# UNITED STATES PATENT AND TRADEMARK OFFICE

10/581,415

<b>Office Action Summary</b>	<b>Application No.</b> 10/581,415	<b>Applicant(s)</b> MAIER ET AL.	
	<b>Examiner</b> MACADE BROWN	<b>Art Unit</b> 3753

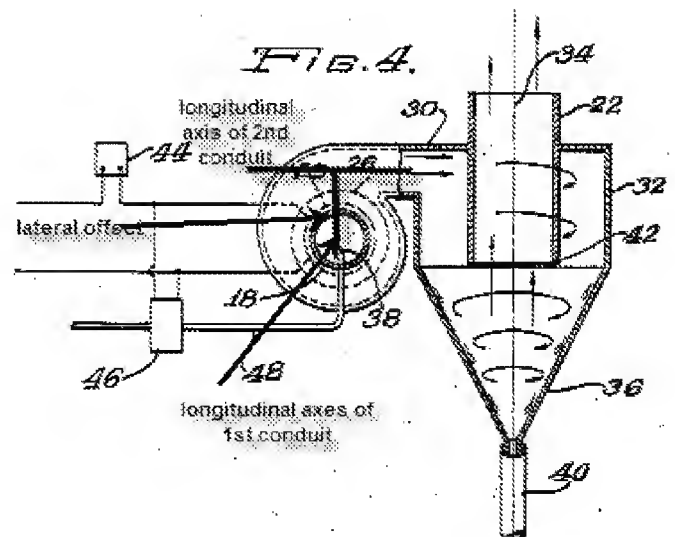
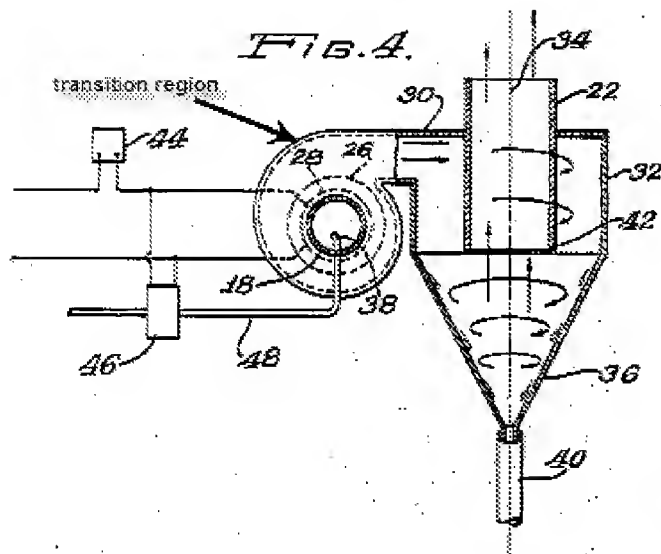
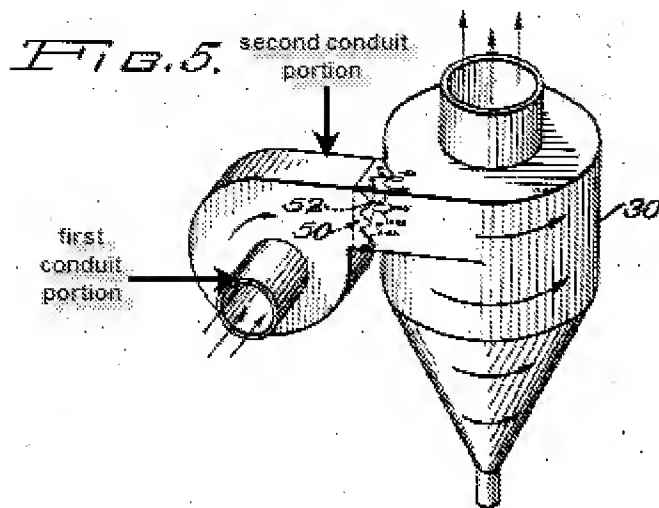
Regarding claims 10-12, and 16-27, Nozaki teaches an inlet valve assembly including a valve element 42 (fig. 4) disposed in a valve chamber 32 and fluid conduit (conduit formed by 18 and the lateral extension of duct 30; see fig. 5 below) adjoining the valve chamber 32 on the upstream side, wherein the fluid conduit has a substantially constant width and is embodied such that a rotation about the longitudinal axis of the fluid conduit is impressed on the fluid stream that flows toward the valve chamber, without a constriction of this fluid stream being produced; wherein the fluid conduit includes a first conduit portion 18 and a second conduit portion (fig. 5 below) adjoining the first conduit portion 18, the longitudinal axes of the first and second conduit portions being at an angle  $< 180$  [deg.] to one another, and the longitudinal axis of the first conduit portion 18 being laterally offset from the longitudinal axis of the second conduit portion; wherein the longitudinal axes of the first and second conduit portions are at least approximately at a right angle to one another (see fig. 5); wherein the first and second conduit portions, in cross section, have at least approximately the same radius, and wherein the lateral offset of the longitudinal axes is greater than the radius (see 4 below); further including a transition region (see fig. 4 below) between the first conduit portion 18 and the second conduit portion (Note: the patentability of a

electrochemical removal of material. *In re Thorpe*, 777 F.2d 695, 698,227 USPQ

964,966 (*Fed. Cir. 1985*)); wherein the transition region includes a wall that is curved

from the first conduit portion 18 to the second conduit portion; wherein the first conduit

portion 18 extends no more than an axially insignificantly distance past the second

conduit portion.
